Official Transcript of Proceedings
NUCLEAR REGULATORY COMMISSION

Title: Meeting of the Advisory Committee
On Reactor Safeguards

Reliability and Probabilistic Risk
Assessment (PRA) Subcommittee

Date: November 19, 2014

Part 1: Suggests that No CPRR Rulemaking Alternative can be a Substantial Safety Enhancement

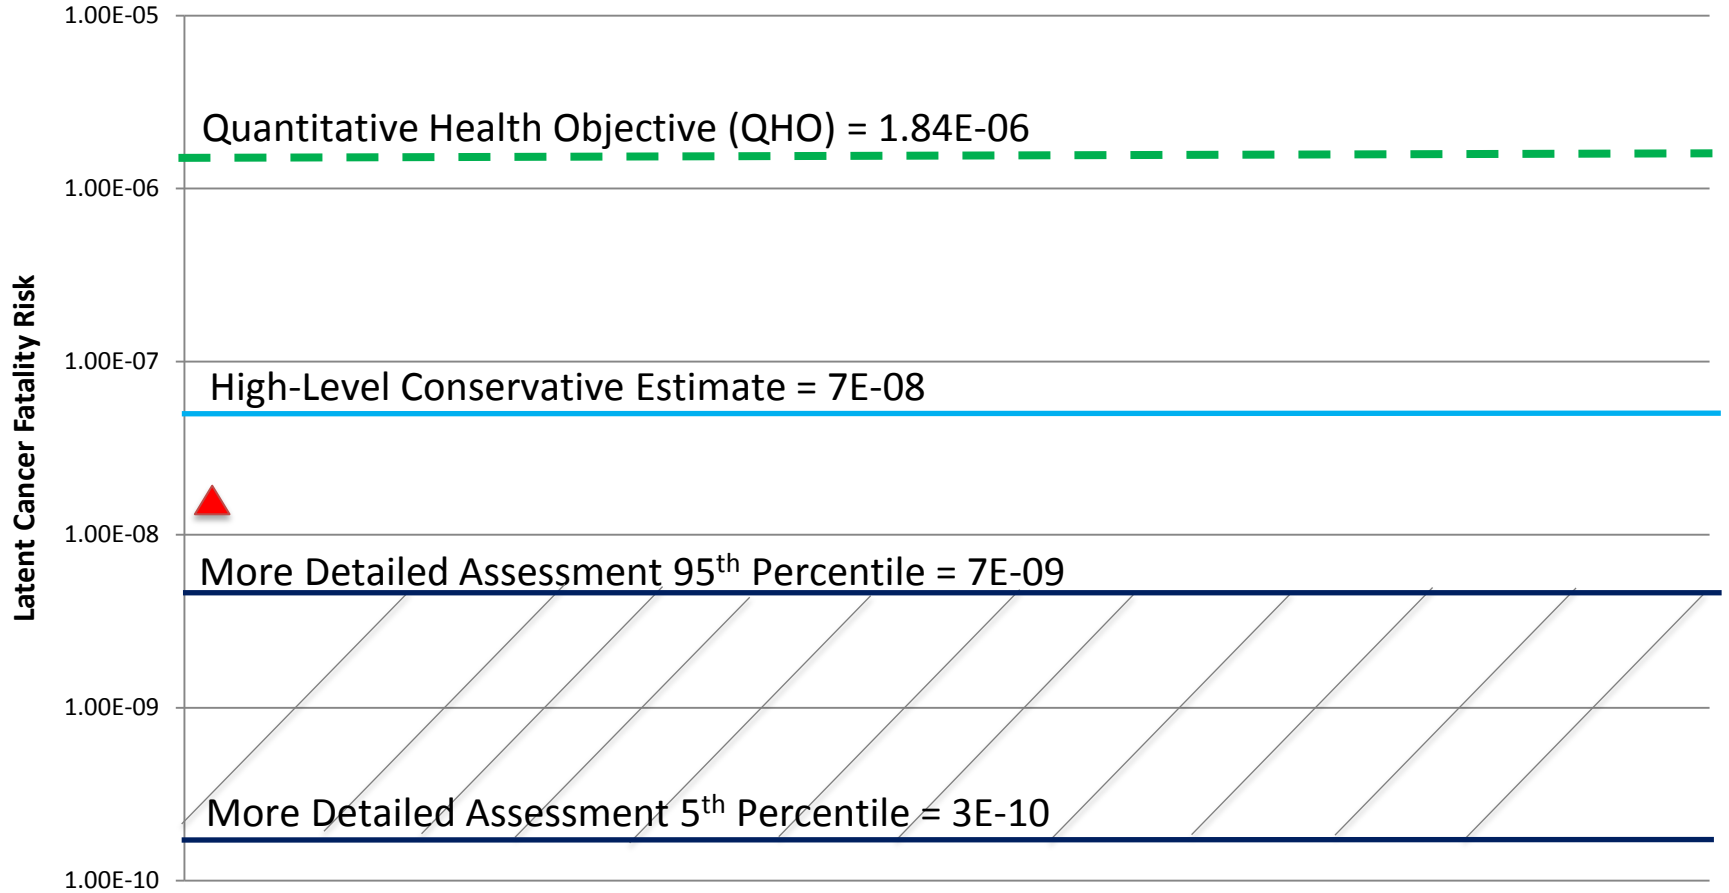
14 MEMBER BLEY; But the blue line is the one
15 we're talking about.

11 CHAIRMAN STETKAR: And, Aaron, I hate to
12 keep bringing you back to this, but that blue line there
13 --

15 CHAIRMAN STETKAR: -- you said that that is
16 accounting only for FLEX, what do you want to call it,
17 prevention or mitigation of FLEX before core melt. Is
18 that value based on Marty's event models?

13 CHAIRMAN STETKAR: It's not that you took
14 99.99 percent credit for the operators to prevent core
15 damage, which then would call into question about where
16 is that blue line relative to the green --

21 MR. SZABO: -- just taking the ELAP
22 frequency --

24 MR. SZABO: -- the highest ELAP frequency
25 and multiplying it times the highest bin MACCS

1 individual latent cancer fatality risk. That's all we
2 did.

7 MR. SZABO: One over times another times
8 0.6 for FLEX is all we did, yes.

Approximate Uncertainty Bounds for Individual Latent Cancer Fatality Risk

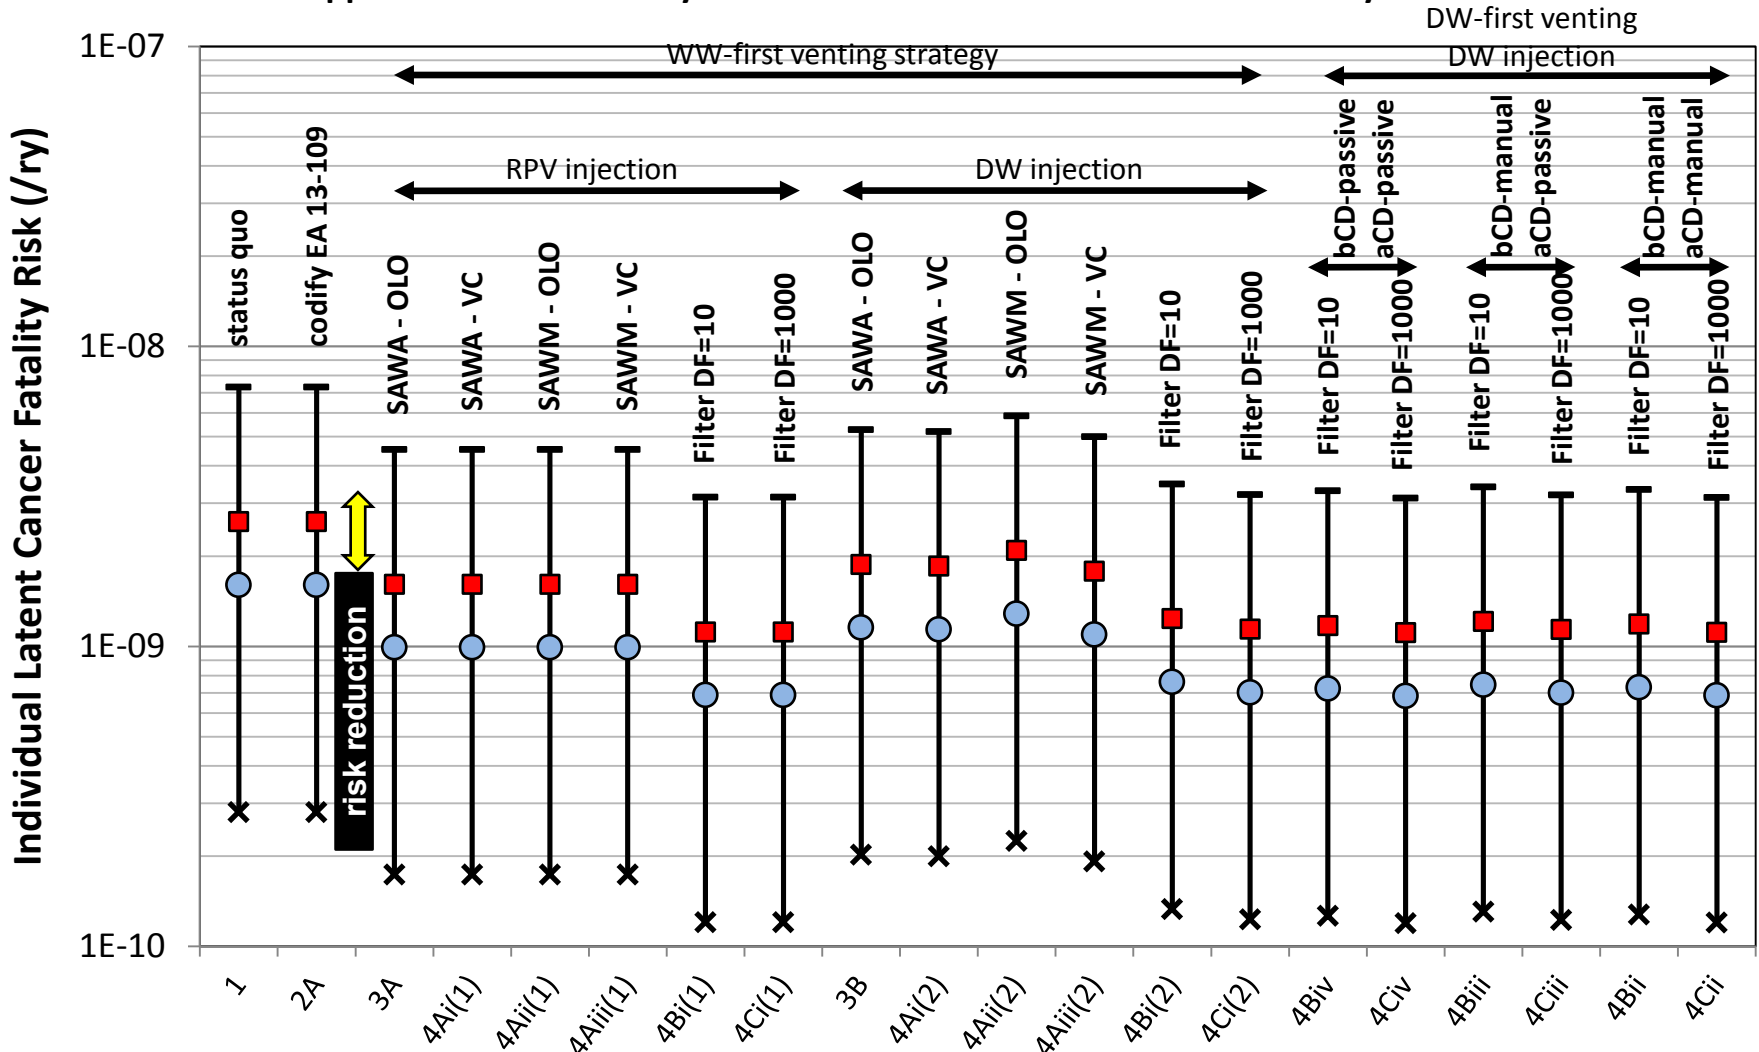
7 CHAIRMAN STETKAR: on the other hand,
8 saying that the operators could not work at all with
9 no uncertainty under some of those seismic scenarios
10 could change some of those error bounds by a factor of
11 anywhere from 3 to 10. So that's my point is it's not
12 -- there's a broader sense of uncertainty here than just
13 what has been quantified by these error bounds, and that
14 is are the humans actually treated correctly within
15 those models? And that's one of the reasons why we had
16 requested this briefing, to kind of dig into that. And
17 we're skirting that issue.

18 But on the other hand the previous
19 comparison that you showed said that it doesn't make
20 any difference. So all of this detail doesn't make any
21 different. My only personal caution is that if you show
22 all of this detail, don't try to assign too much
23 confidence in the fact that any of these things represent
24 reality regardless of what uncertainty or within the
25 context the source of that uncertainty.

21 Just one other -- I agree with John, but
22 just for the graphic, I think I know what you're trying
23 to show, but that black box that says "risk reduction"
24 and the double-ended yellow arrow doesn't -- I don't
25 know what the heck that means.

3 MEMBER BLEY: I'd almost get rid of -- I
4 would get rid of it unless you can make it more clear
5 what you're trying to show.

20 MEMBER BLEY: So either clean it up or get
21 rid of it, or live with it and get questions.

8 MEMBER SCHULTZ: I would think it would be
9 broader than that, because in the high-level evaluation
10 you've done; I agree with Dennis, this is not the right
11 way to determine the breadth of the yellow arrow band
12 there, but there's something that certainly is learned
13 in the evaluation that's done that frames the benefit
14 to be gained against one evaluation criterion that
15 provides good information about what benefit might be
16 achieved here. And one would think if you change the
17 metric evaluation you were doing it may not -- it
18 wouldn't appear that it would change the relative
19 benefit that would be gained for this class of reactors,
20 at least.

1 orders of magnitude between the alternatives and that
2 it's merely just a small portion of something that's
3 been -- the uncertainty analysis, while it includes
4 human error probabilities in MACCS is dominated by the
5 seismic uncertainty, which improving the human error
6 probabilities would not change.
